**Remarks**

Reconsideration of this application is requested. By this response to the Office Action dated August 26, 2004, claims 1-3 and 17-19 were amended and claims 14-16 and 20-21 were canceled. A listing of these claims and the actions taken is included in this amendment. Claims 1-3 and 17-19 remain in the application.

Figure 3

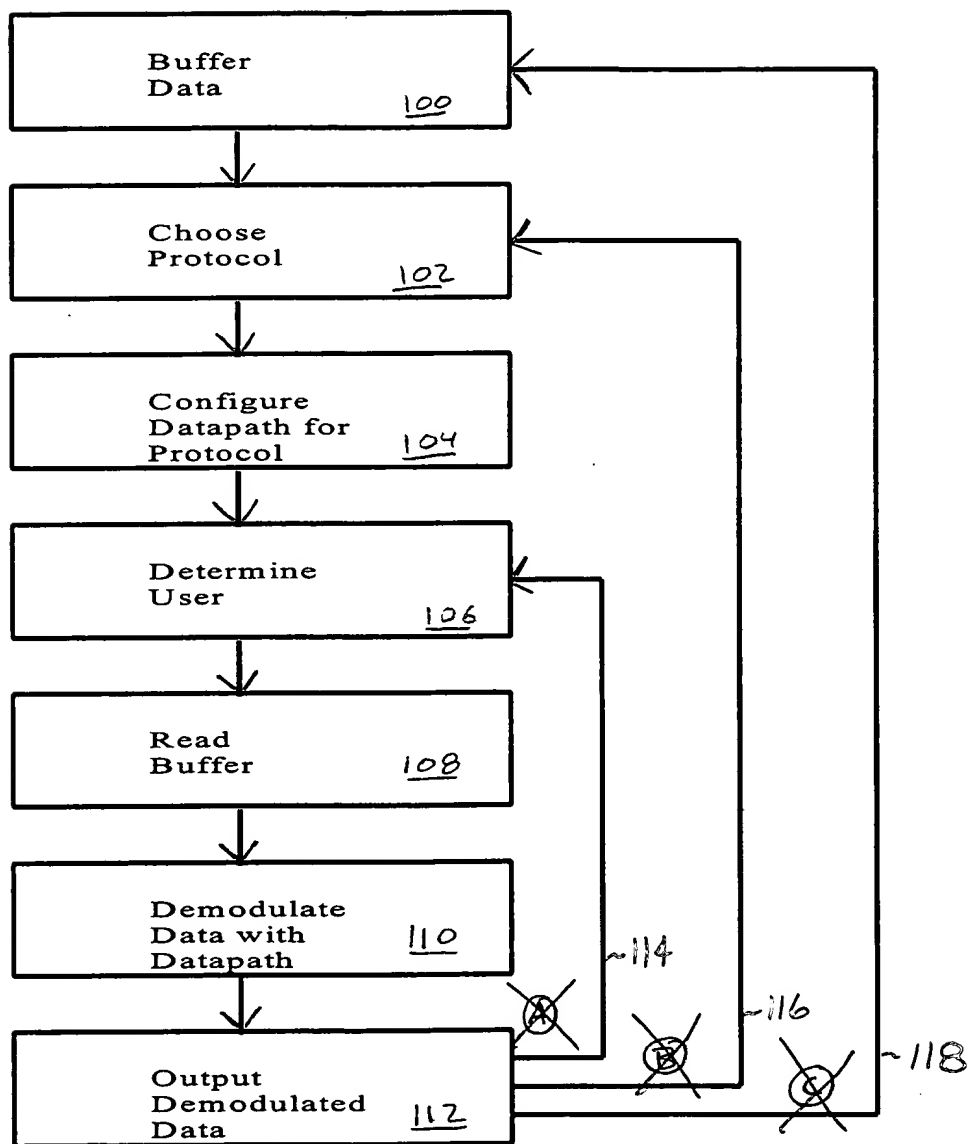
The drawings were objected to because FIG. 3 included encircled letters "A", "B" and "C". The Examiner further objected to the drawings, in particular FIG. 4, for failing to comply with 37 CFR 1.84(p)(5).

Applicants are enclosing a copy of FIGs. 1-3 with red markings to indicate proposed changes. Note that the new FIG. 3 is submitted with the encircled letters having been removed from the figure and reference numbers substituted. Also, by this amendment, FIG. 4 has been removed along with the mention of this figure in the Brief Description of the Drawings and in the specification.

Additional changes to the specification have been made to correct the use of encircled letters in FIG. 3. The replacement of encircled letters made in the figure have been also corrected in the specification.
